## Committee of Experts on the Transport of Dangerous Goods and on the Globally Harmonized System of Classification and Labelling of Chemicals

**Classification criteria and related hazard communication:  
review of Chapter 2.1**

## **Amendments to the decision logics for explosives in Chapter 2.1 as proposed in ST/SG/AC.10/C.4/2020/18**

### **Transmitted by the expert from Germany**

5. The amended decision logic 2.1 (a) is shown in the following:

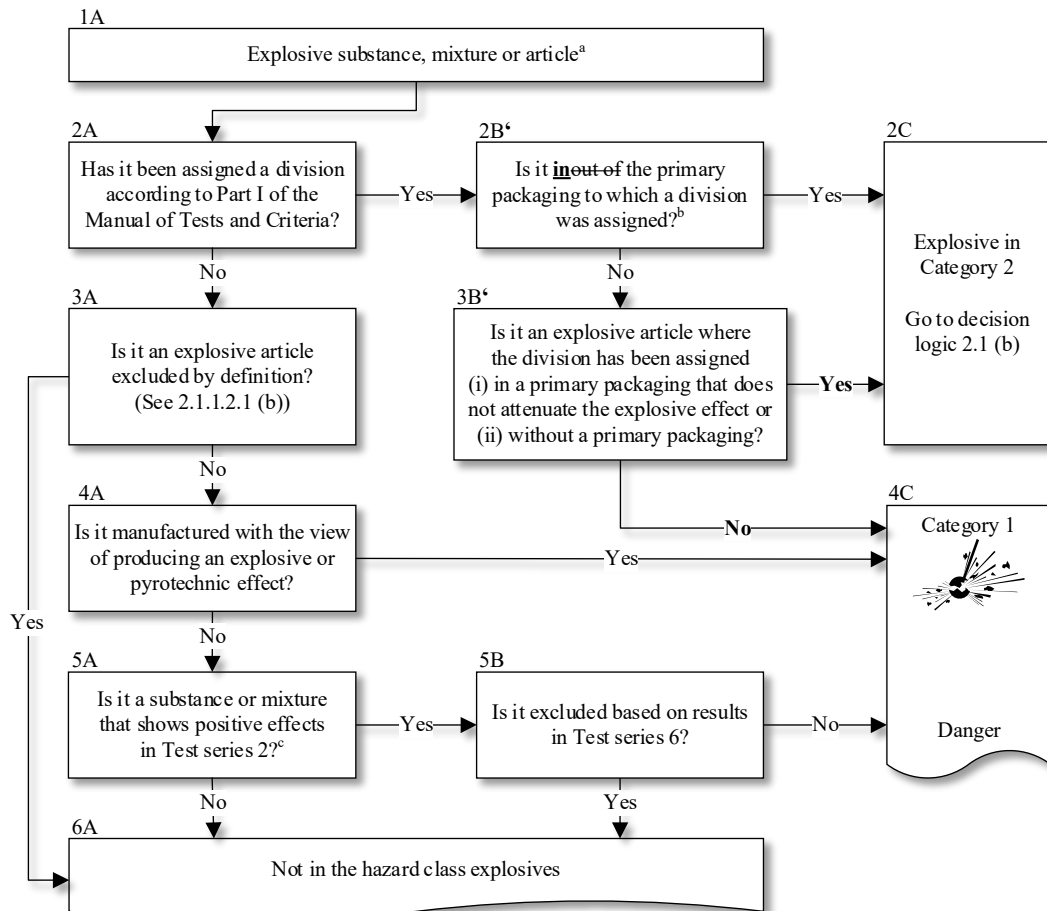
2. We propose to switch the order of the boxes 2B and 3B in decision logic 2.1 (a) as shown in the decision logic in paragraph 5 below.

(a) The order of the boxes would be in line with the order of the criteria in the criteria table (see Annex II of ST/SG/AC.10/C.3/2020/20/Add.1–ST/SG/AC.10/C.4/2020/5/Add.1).

(b) The more general question that concerns also substances and mixtures would be asked before the specific one relating only to articles. The current order could be confusing because the reader might not understand (immediately) that the question in box 3B in ST/SG/AC.10/C.4/2020/18 refers not only to articles but to substances and mixtures as well because it comes after a box that relates to some special articles only.

4. In order to avoid possible confusion about articles that do not have a primary packaging, it is proposed to slightly amend the wording in box 2B' (shown in the decision logic in paragraph 5 below) and in 3B' as follows:

(a) Current wording in 2B: "Is it an explosive article assigned to a division without a primary packaging or in a primary packaging that does not attenuate the explosive effect?"

(b) Proposed wording for 3B': "Is it an explosive article where the division has been assigned (i) in a primary packaging that does not attenuate the explosive effect or (ii) without a primary packaging?"

The proposed wording aims at clarifying that, for the answer to this question, it is not relevant whether the article actually is in a primary packaging. The primary packaging is considered only with regard to its role in the division assignment.

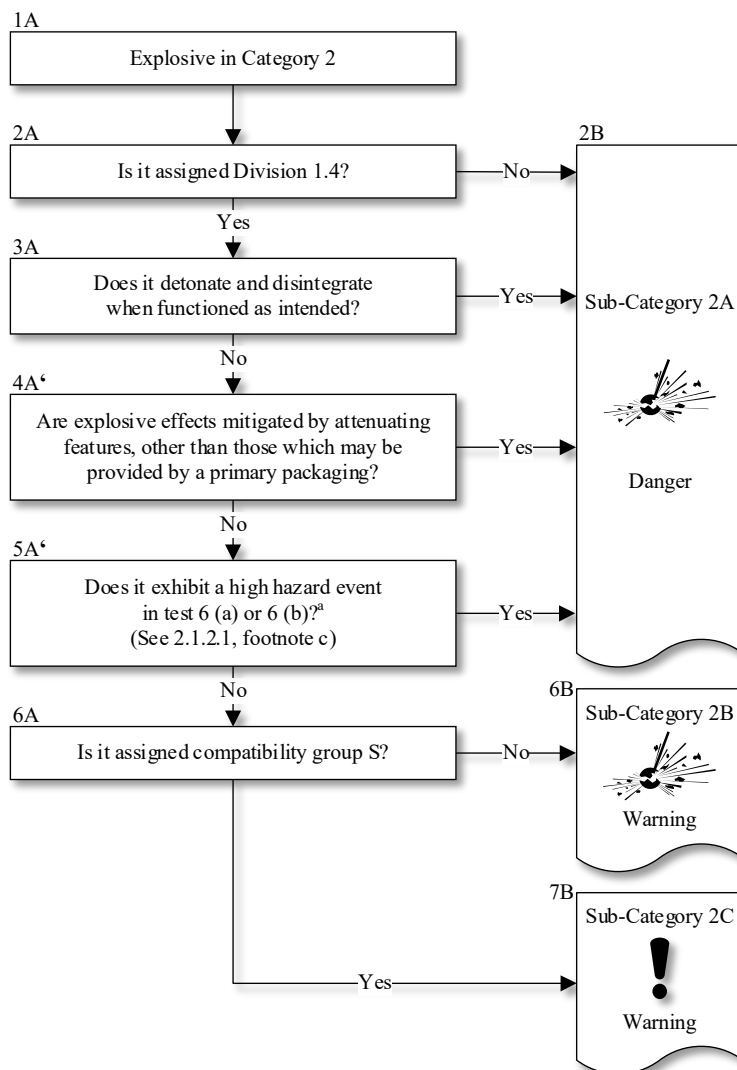
6. We propose to switch the order of the boxes 4A and 5A in decision logic 2.1 (b) as shown in paragraph 10 below.

7. This would have the following advantage: It is easier to decide whether attenuating features of the packaging are present than to find out whether there was a high hazard event in test 6 (a) or 6 (b) (which appears to require digging out old test reports). Thus, we think that the question about attenuating features should be asked first. If they are present, it is not necessary to look at test 6 results for the purposes of sub-category assignment at all.

8. In order to avoid reference to test 6 (a) or 6 (b) in the new box 4A' (because it then is before the box on test 6 (a) and (b)), we also propose a slight rewording of that box, as shown in paragraph 9 below. The wording then would also be in line with the one in box 3B' in the above decision logic and thus also with the wording proposed in ST/SG/AC.10/C.4/2020/18 (see box 2B of decision logic 2.1 (a) in that document). In decision logic 2.1 (a) the packaging is supposed to be assessed with regard to attenuation of explosive effects (which can be assessed based on expert judgement) but not with regard to the specific potential to mitigate a high hazard event in test 6 (a) or (b) (which rather would be guess work).

9. The wording in box 4A' thus is proposed to be amended as follows:
- Current wording in 5A: "Is a high hazard event mitigated by attenuating features, other than which may be provided by a primary packaging?"
  - Proposed wording for 4A': "Are explosive effects mitigated by attenuating features, other than those which may be provided by a primary packaging?"
10. The amended decision logic 2.1 (b) is shown in the following:
